Sporting Bulletin no. 5

Subject: Sealing of the Junior CrossCar Restrictors

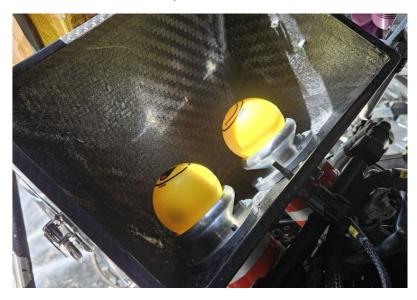
For the 2024 season, all Junior CrossCar restrictors will be sealed. The sealing will be done from the mounting clamps on the restrictors to the mounting clamps on the throttle unit.

The fixing of the restrictors onto the throttle unit must only be carried out with superclamps.

The teams must prepare the heads of the screws of the superclamps with a 2.5-mm bore so that they can be sealed.

The FIA seals will be affixed by the FIA Technical Delegate during the pre-event scrutineering.

Closing the restrictors with a plug as shown below must cause the engine to stop immediately.
